Waste Storage and Transportation Plan – Amendment 1

Phase I – Asbestos and COPC Abatement and Removal Phase II – Structural Deconstruction 130 Liberty Street Deconstruction

This Addendum 1 modifies and amends certain provisions of the approved Waste Storage and Transportation Plan, dated September 7, 2005. Such modifications and amendments shall be incorporated into, and become part of, the Waste Storage and Transportation Plan.

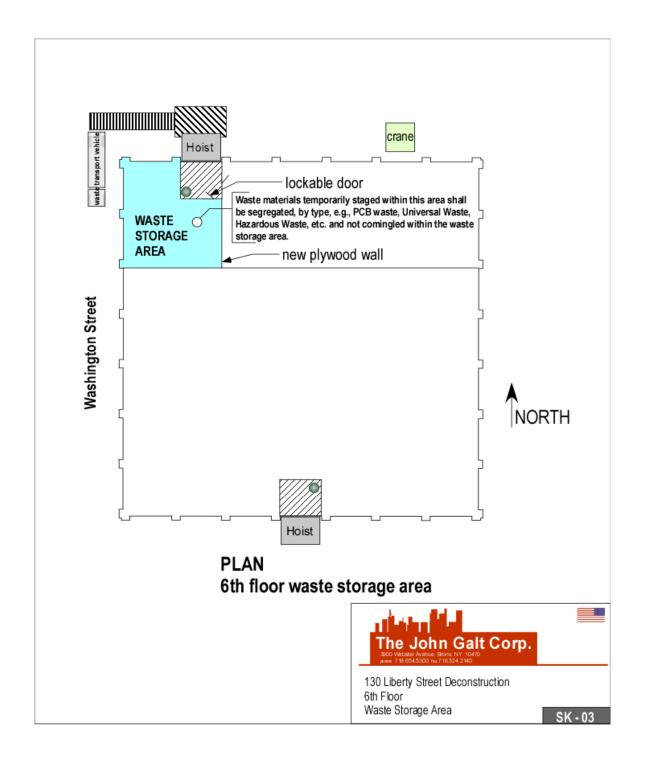
- 8. Replace previous SK-03 with revised SK-03, page 4 this document.
- 9. Page 10 of 17, III. WASTE MANAGEMENT, item 6. Delete and replace with:

- 10. Page 10 of 17, III. WASTE MANAGEMENT, delete item 7 sentence referencing storage in 1st floor area and add 'PCB waste shall be staged in the 6th floor storage area designated in figure SK-03'.
- 11. Page 11 of 17, III. WASTE MANAGEMENT, delete item 9 sentence referencing storage in 1st floor area and add 'Universal waste shall be staged in the 6th floor storage area designated in figure SK-03'.
- 12. Page 13 of 17, II. WASTE MANAGEMENT, Add:
